PITTSBURG UNIFIED SCHOOL DISTRICT

FOOTHILL ELEMENTARY SCHOOL & HIGHLANDS ELEMENTARY SCHOOL

– PLAY STRUCTURES REPLACEMENT PROJECT

Addendum No. 1

Foothill Elementary - Lower 2
Pittsburg, CA

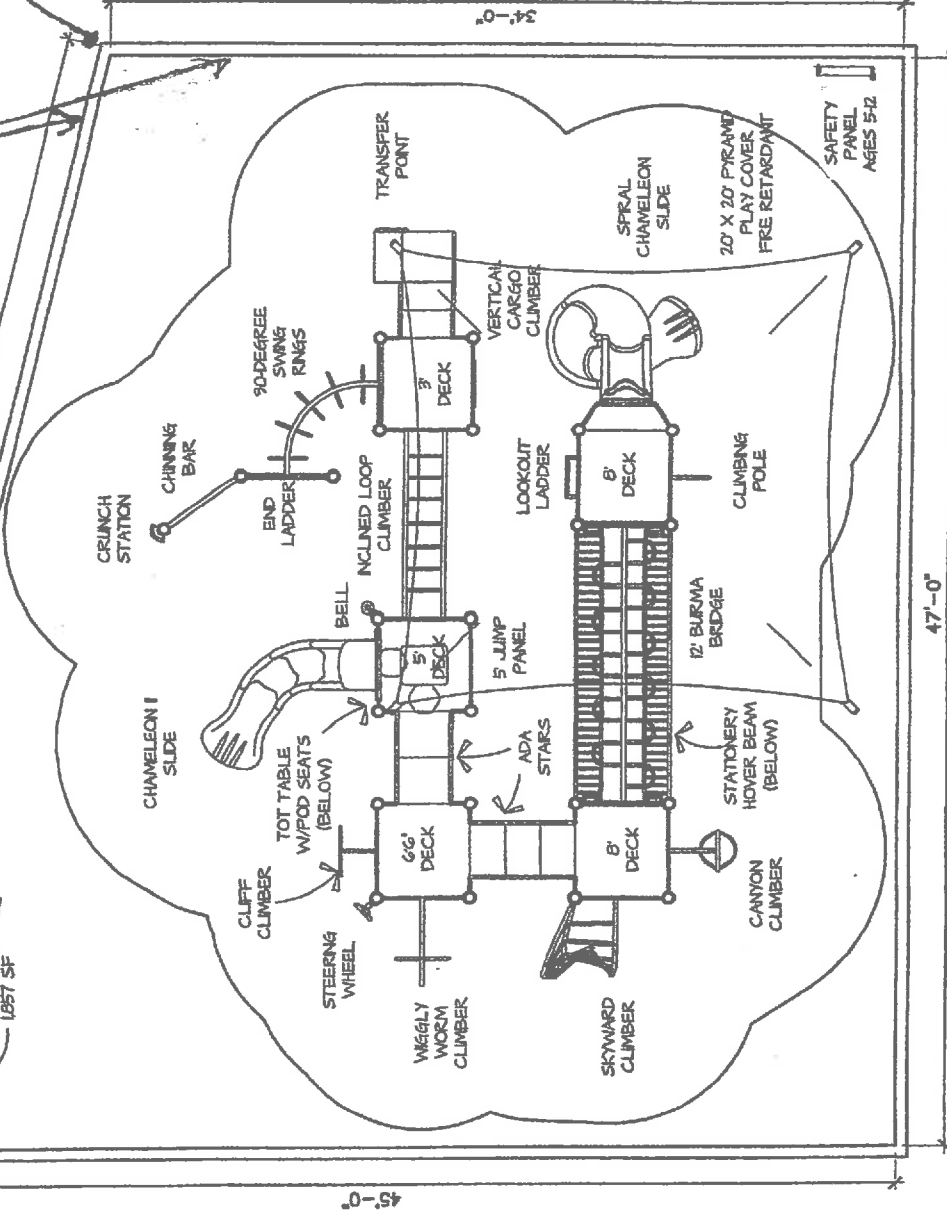
- a. Document 01 11 00 – Summary of Work: At Paragraph 1.02.A., add the following listed scope of work items to the Summary of Work –
 - At Foothill ES, Lower 2 Play Structure – Demolish & dispose of the existing concrete ramp and the concrete curb wall Play Structure Surround.
 - At Foothill ES, Lower 2 Play Structure – Salvage the existing wood fiber Safety Surface material, and then transport it to the City Park on the corner of Alturas Avenue and Riverview Drive in Pittsburg, CA. The material is to then be dumped in a designated area, at the City Park, for spreading by others.
 - At Foothill ES, Lower 2 Play Structure – Furnish & install a new concrete curb wall Play Structure Surround, with chain link fence, as per the attached revised Layout Plan and the attached Concrete Wall Detail Sheet.

NEW T.O.W.
APPROX. 34"
ABOVE AC
PAVING

NEW T.O.W.
APPROX. 29"
ABOVE AC
PAVING

DEMO EXIST CURB
REPLACE WITH NEW
CURB/WALL AND FENCE

CONCRETE WALL

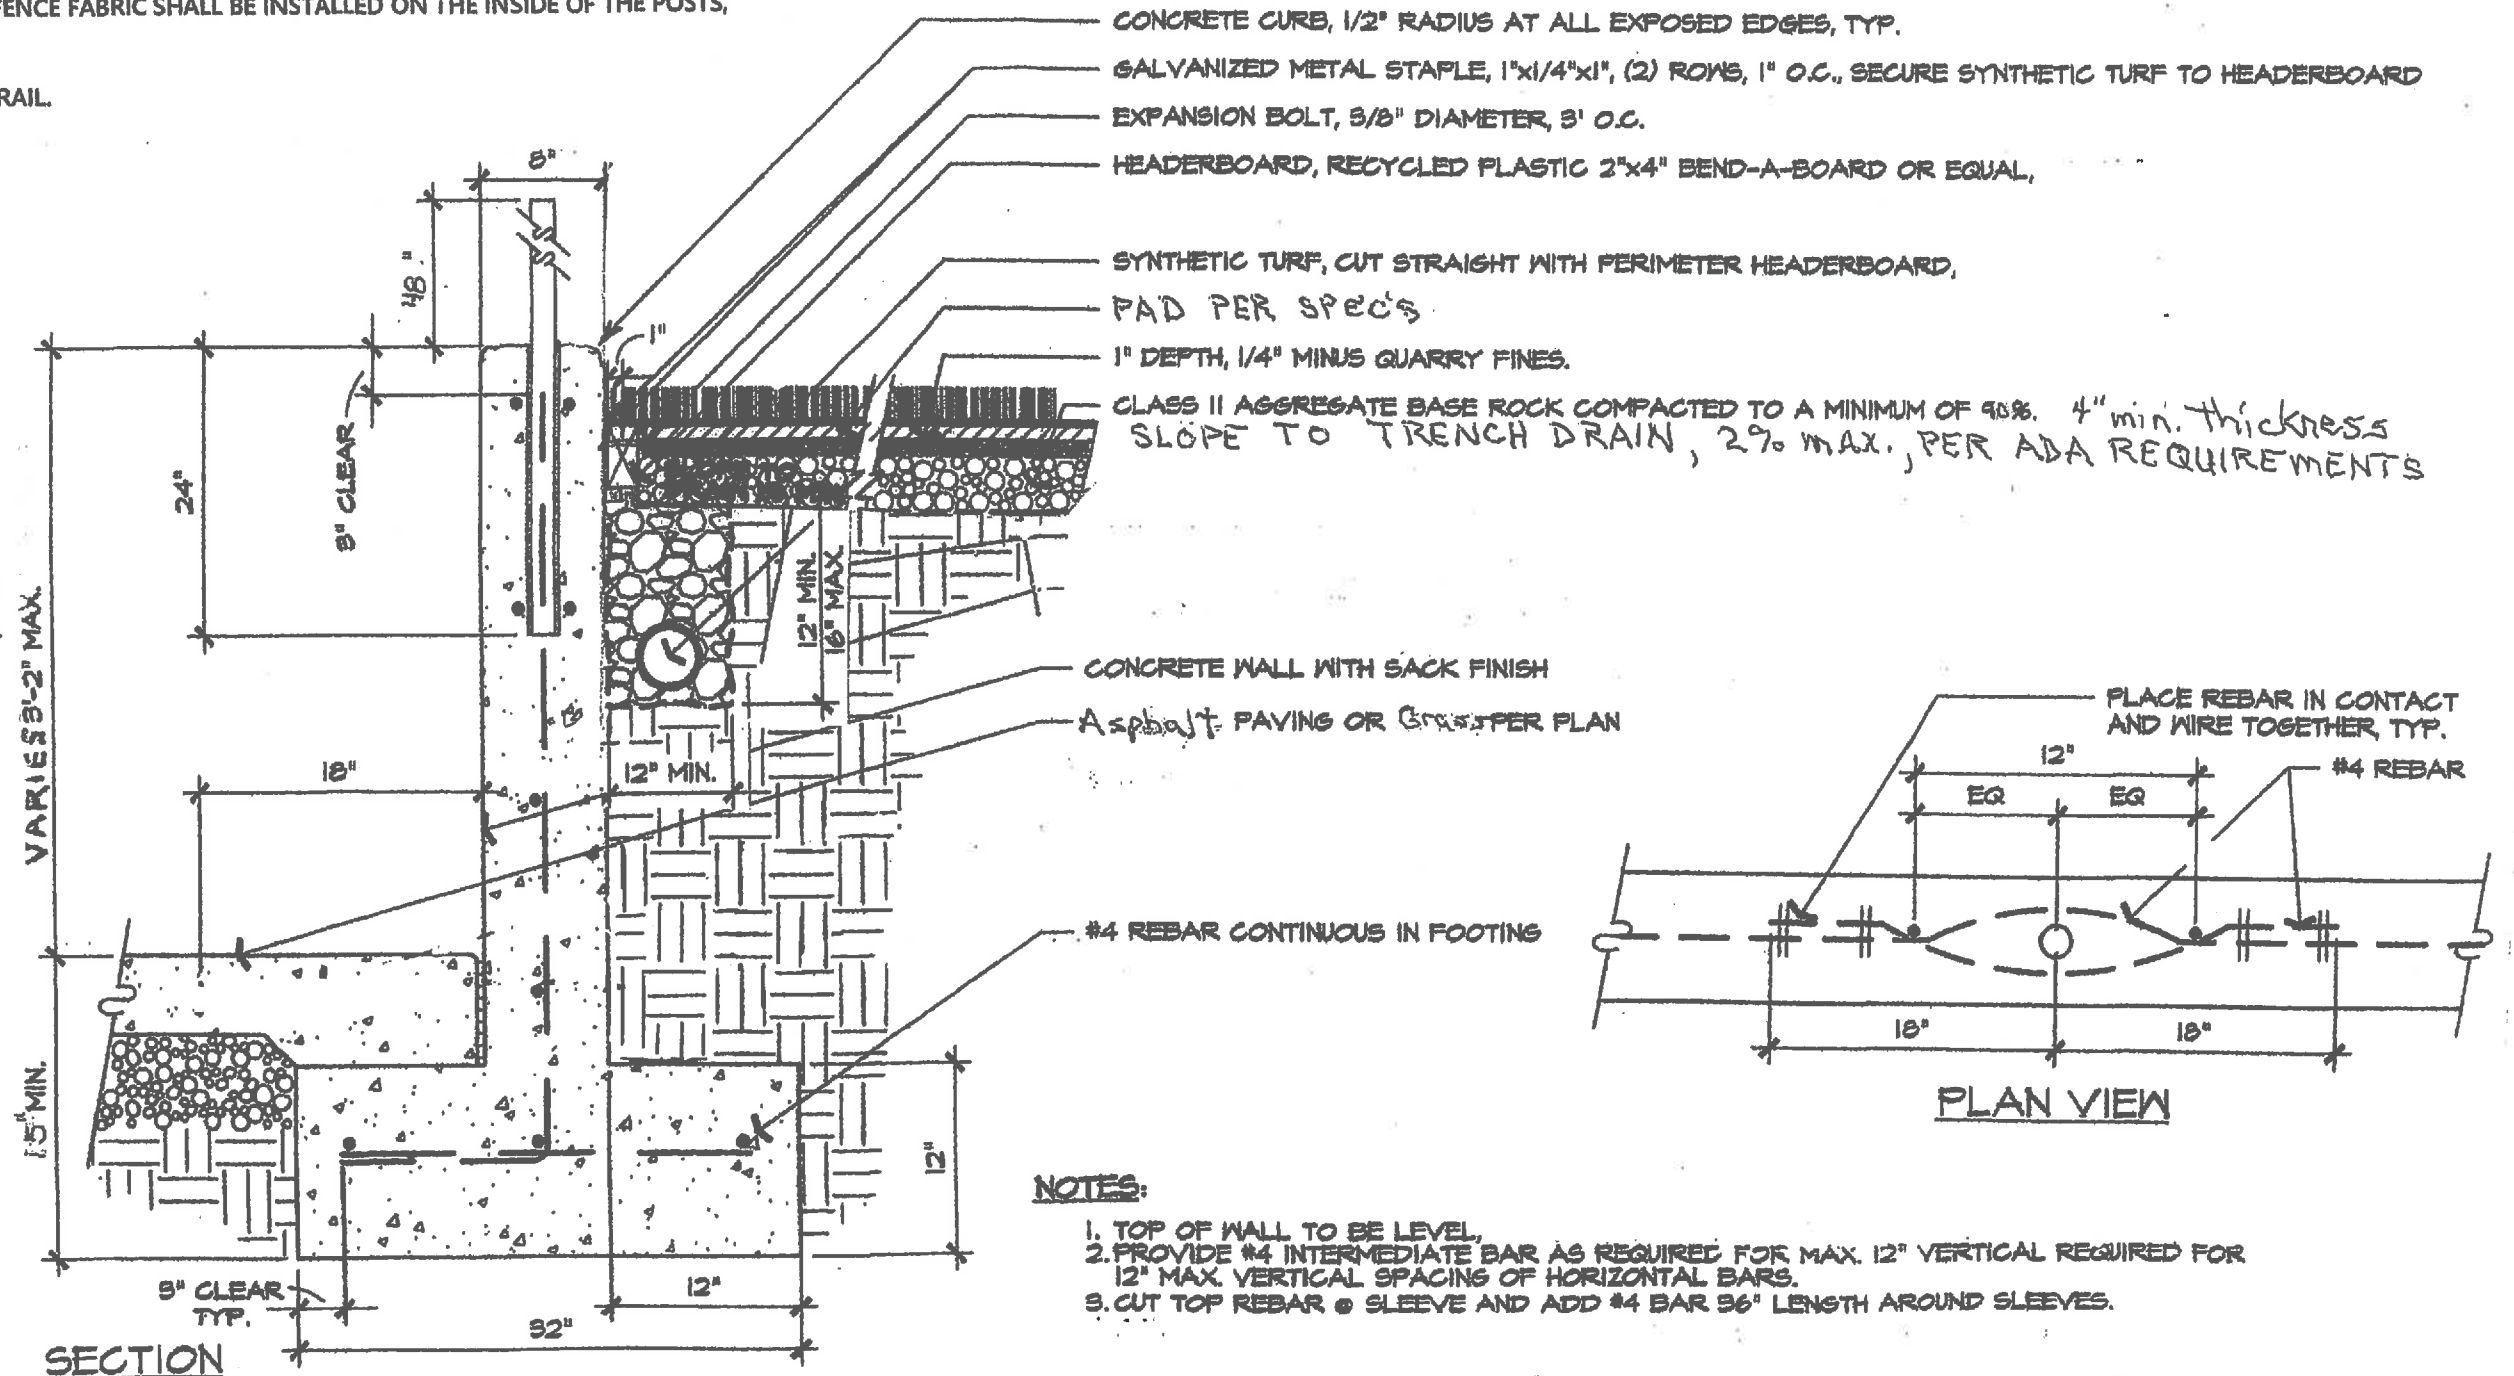
1. PROVIDE 48" GALVANIZED FENCE ALONG TOP OF NEW CURB/WALL.
2. GALVANIZED POST SLEEVES SHALL BE EMBEDDED 24" INTO WALL. WHERE CURB/WALL IS LESS THAN 28" IN HEIGHT, FROM BOTTOM OF FOOTING TO TOP OF WALL, THE POSTS SHALL BE INSTALLED IN A 12" ROUND BY 27" DEEP POST FOOTING, WITHOUT A SLEEVE, BELOW BOTTOM OF CURB/WALL. CURB/WALL SHALL THEN BE POURED TIGHT AROUND THE POSTS.
3. POSTS SHALL BE EVENLY SPACED ALONG EACH SIDE OF THE PLAY AREA, 10' MAX. SPACING.
4. 2" GALVANIZED CHAIN LINK FENCE FABRIC SHALL BE INSTALLED ON THE INSIDE OF THE POSTS, TOWARD THE PLAY AREA.
5. PROVIDE TOP AND BOTTOM RAIL.

1. TURF SHALL BE INSTALLED LEVEL WITH EXISTING SIDEWALK.
2. SLOPE TURF AREA MAX. 2% TOWARDS THE NORTH, AWAY FROM THE SIDEWALK. AREA SHALL BE LEVEL EAST/WEST DIRECTION, EXCEPT ALONG SIDEWALK. THERE IS A 3/4" ELEVATION DIFFERENCE IN THE SIDEWALK LENGTH.
3. TRENCH DRAIN SHALL BE 4" PVC SCH. 40 PERFORATED PIPE, SLOPED TO DRAIN WEST, WITH THE PIPE EXTENDING THROUGH THE CURB/WALL, 3/4" CRUSHED ROCK, WRAPPED IN DRAIN FABRIC.

1. SPREAD FOOTING NOT REQUIRED FOR CURB/WALL, WHERE HEIGHT IS LESS THAN 12" ABOVE ADJACENT GRADE.
2. PROVIDE 8" WIDE TALL CURB WHERE SPREAD FOOTING IS NOT REQUIRED, WITH 12" OF DEPTH BELOW ADJACENT GRADE, PROVIDE #4 REBAR SAME SPACING AS WALL REBAR.

1. TOP OF WALL TO BE LEVEL.
2. PROVIDE #4 INTERMEDIATE BAR AS REQUIRED FOR MAX. 12" VERTICAL REQUIRED FOR 12" MAX. VERTICAL SPACING OF HORIZONTAL BARS.
3. CUT TOP REBAR @ SLEEVE AND ADD #4 BAR 96" LENGTH AROUND SLEEVES.
